List of Errata

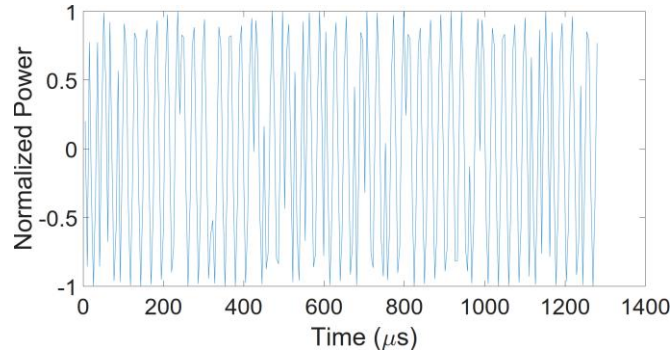
- [1] Page 18, Figure 2.2 needs to be replaced by the figure below, because the current figure is not showing the actual signal transmitted by the satellites (as stated in the caption) but the demodulated signal in the baseband model.

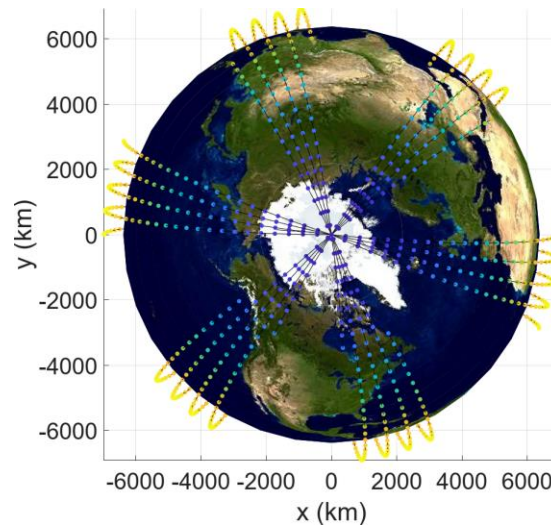
[9] Page 84, Figure 4.4d needs to be replaced by the figure below
